UNT SYSTEM™

DATE: February 28, 2025
TO: Potential Respondents
FROM: Carrie Stoeckert—Construction Contract Expeditor III
SUBJECT: Addendum #1
RFQ752-25-1004CS
Chilton Hall 111 Renovation

ADDENDUM NO. 01

PROJECT: Chilton Hall Level 1 Renovation
HE0569.240100

LEVEL 1 FLOOR PLAN -
DEMO PLUMBING

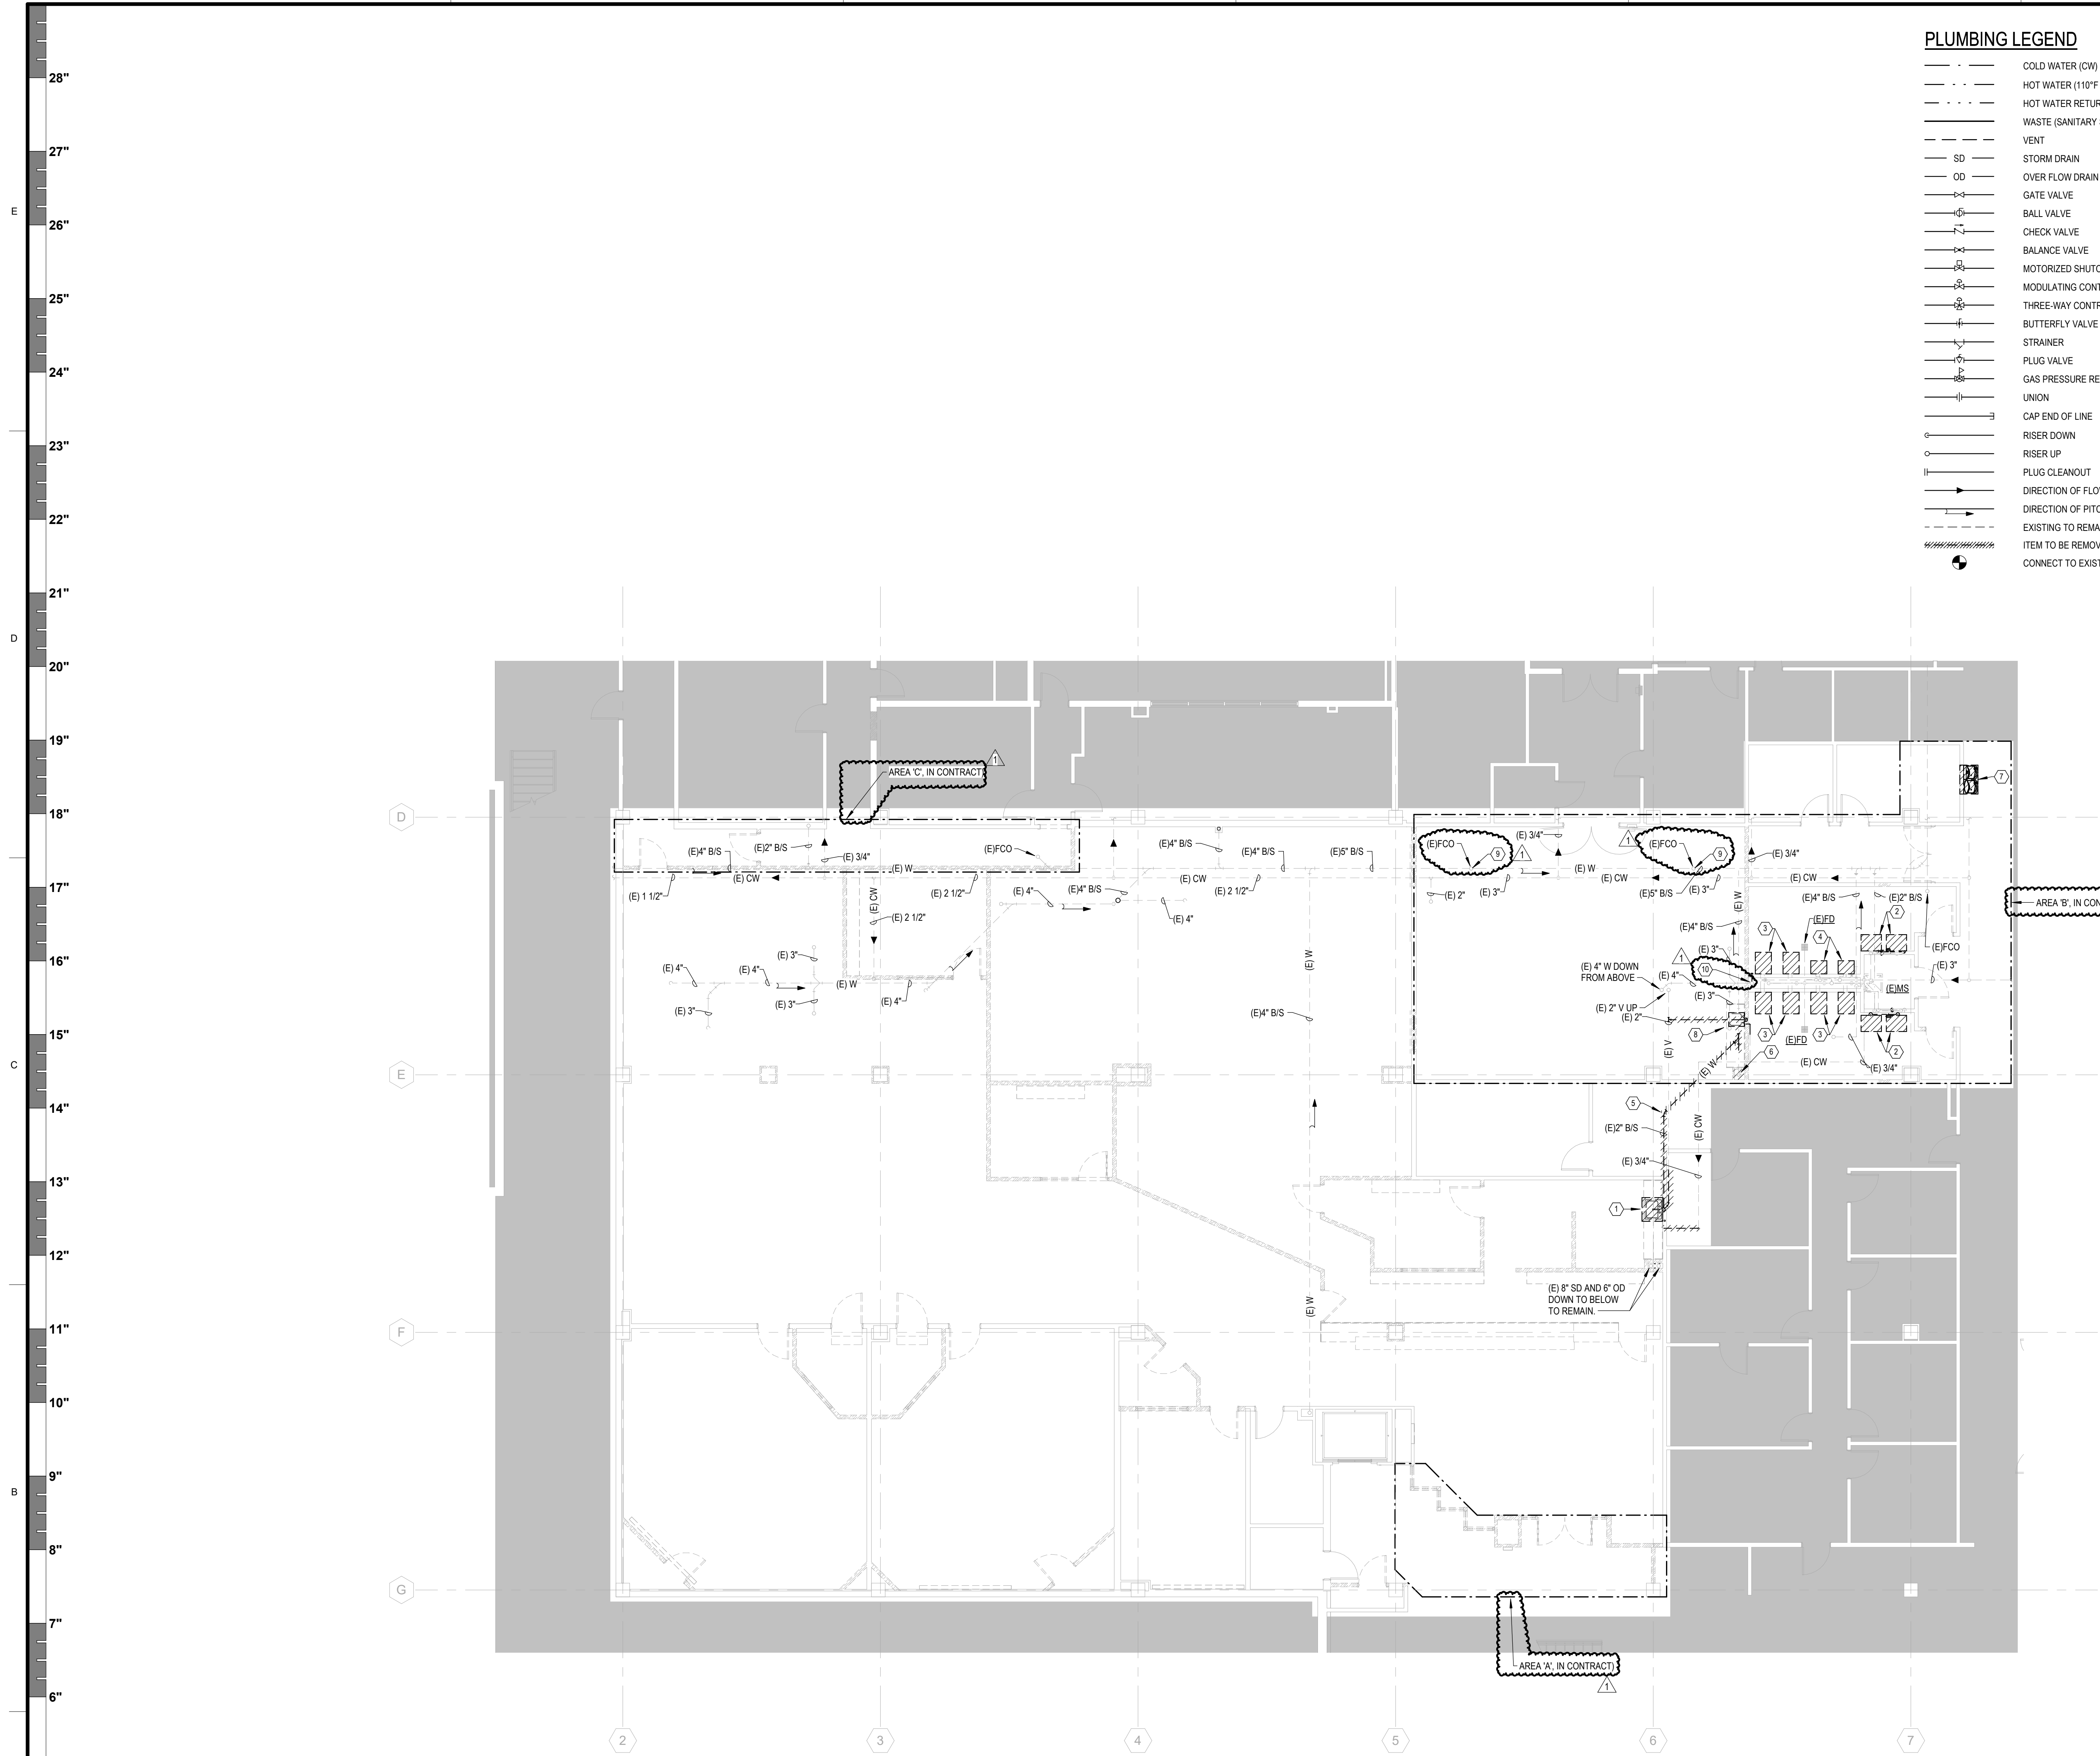
1.25	<u>M301</u>
	A. MODIFIED: Mechanical general notes #17. B. ADDED: Mechanical general notes #19, #20, and #21.
1.26	<u>PD101</u>
	A. UPDATED: Area A, B, & C note on the floor plan. B. ADDED: Location of existing floor cleanouts and existing couplings to be replaced. C. ADDED: Notes by symbol #9 and #10. D. ADDED: Sheet notes #3, #4, and #5.

ED201

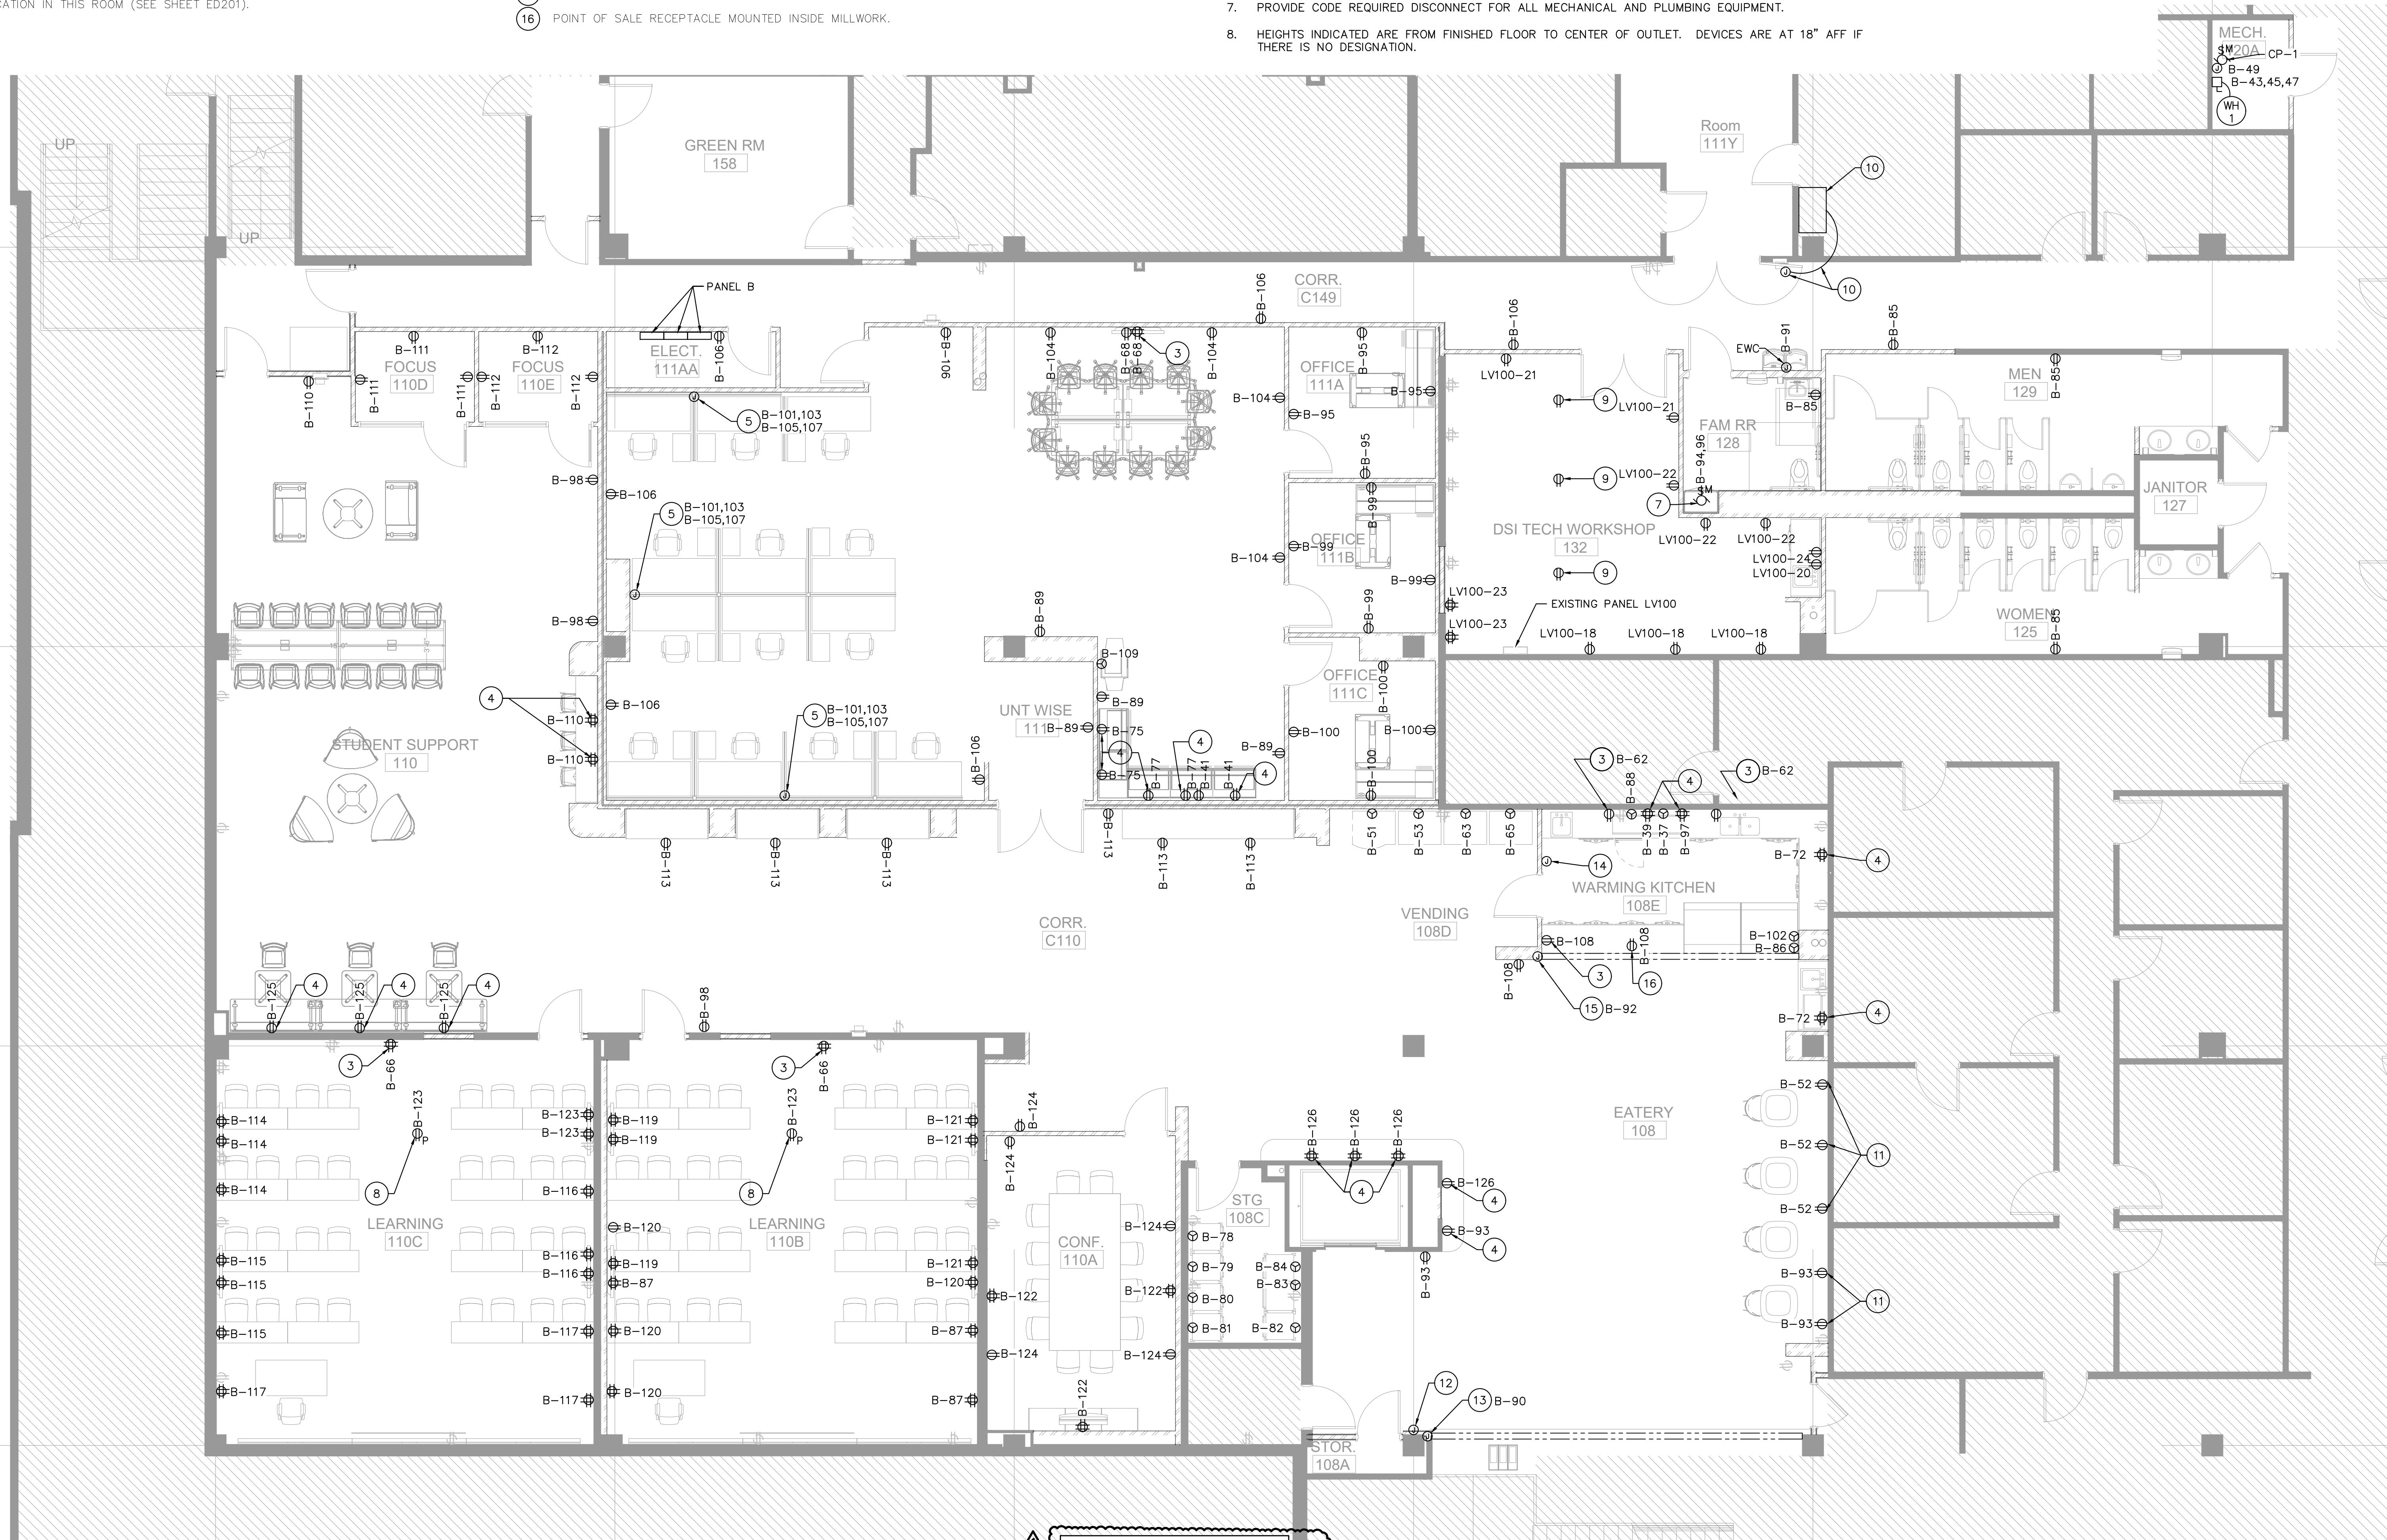
1.16	<u>S2.02 SECOND FLOOR FRAMING PLAN</u> A. Added detail reference.
1.17	<u>ED201</u> A. Called out location of main electrical room for reference. Called out (2) locations where conduits need to be investigated and rerouted.
